Architectural Review Board Meeting Agenda

Thursday, October 17, 2024 at 5:30 p.m.

Agenda Item #1

Project: 24-2307-FENCE/ARB
Address: 1455 Camellia Circle
APN: 003-590-023
Zoning: Single Family Residential (7-R-1)
Applicant: Holly Minear & Hans Almgren

Photo #2: Side view of tiered fencing – facing west

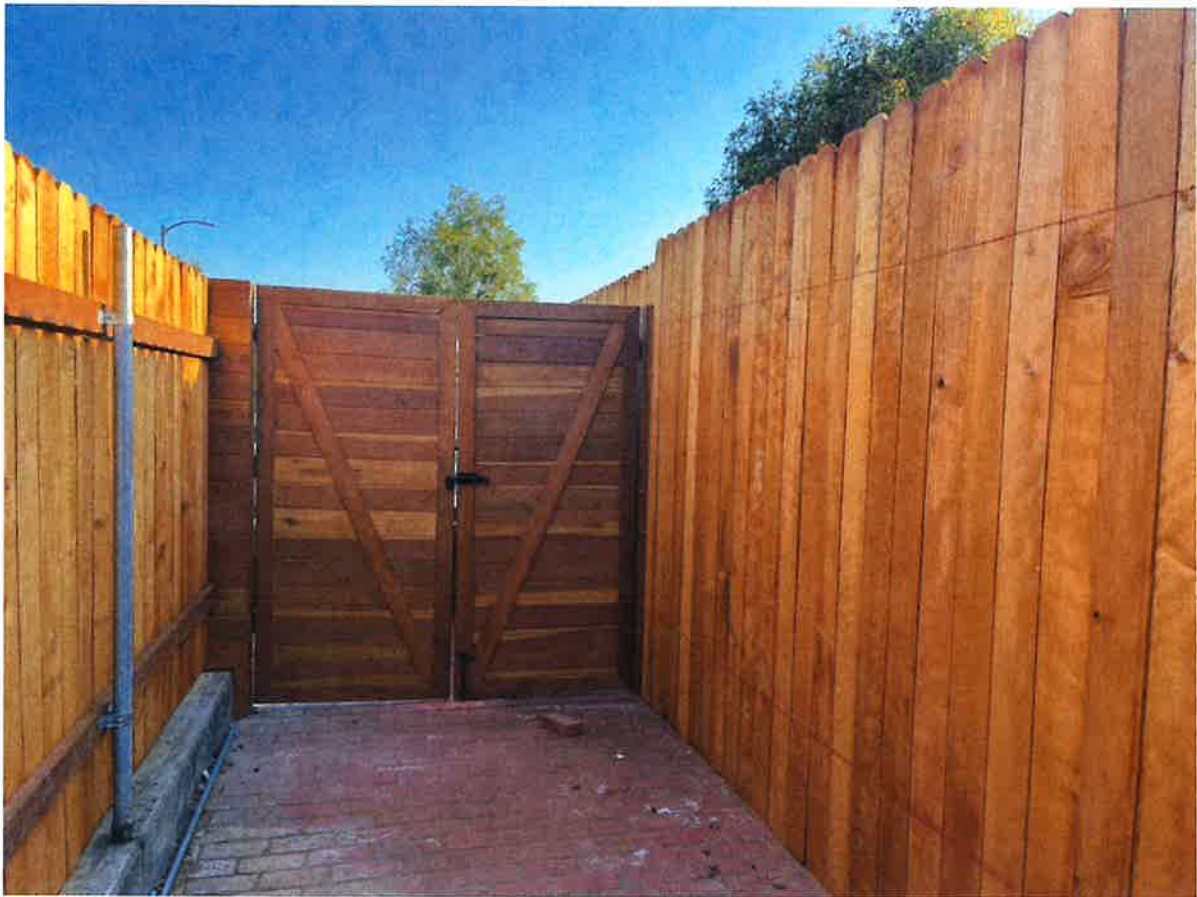
As described above, the proposed "as-built" fencing in the front yard is a double-sided solid redwood dog-ear fence. The fence is located on the property line between two driveways and terminates at the sidewalk without the preferred two-foot separation from the back of the sidewalk. Currently, there is no landscaping between the fence and the sidewalk.

The Board should comment on the height, design, and location of the fence.
